CITY OF ALBUQUERQUE

**Re: Rion Square, 6200 Montgomery Blvd. NE,
(G-18/D029A)
Approval of Permanent Certificate of Occupancy,
Engineer's Stamp Dated: 8-08-08
Certification dated 7-23-2008**

PROJECT TITLE: RION SQUARE

SHEET NO.
CR-1

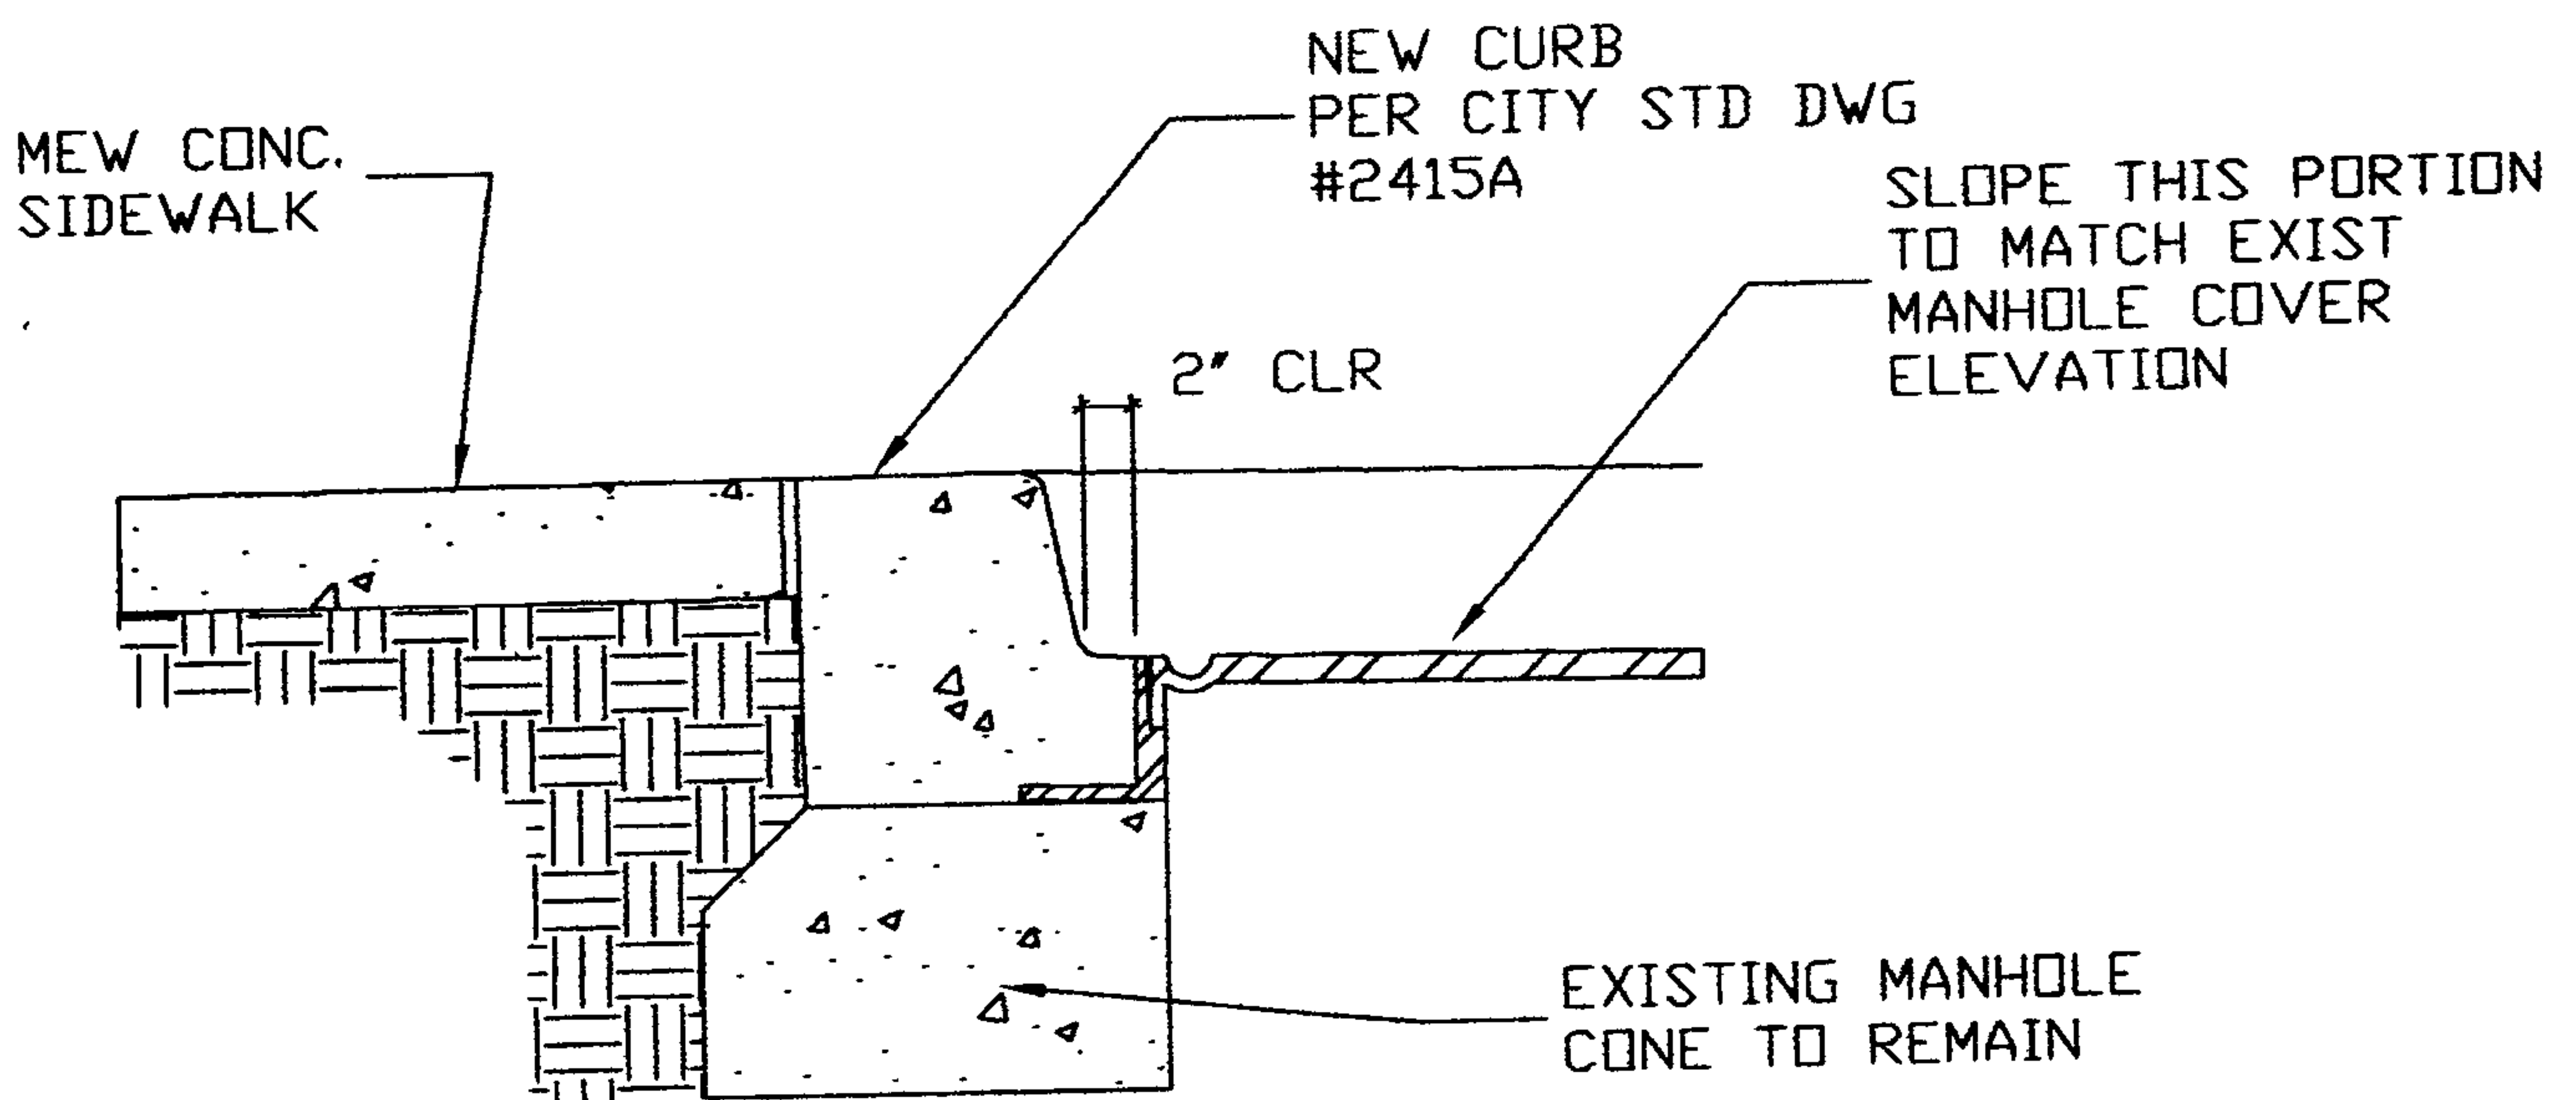
There is also a manhole rim in the gutter flow line on San Pedro. The other 2 pictures show it as constructed. It includes a curb offset around the rim but does not include concrete to the rim. This hole has filled with trash and allows drainage to get under the pavement. How do you want us to fix this about 3" wide hole around the rim?

There is also a manhole rim in the gutter flow line on San Pedro. The other 2 pictures show it as constructed. It includes a curb offset around the rim but does not include concrete to the rim. This hole has filled with trash and allows drainage to get under the pavement. How do you want us to fix this about 3" wide hole around the rim?

he gap between the rim and the curb should be filled in with some kind of cementitious grout. We don't want drainage to get under the pavement.
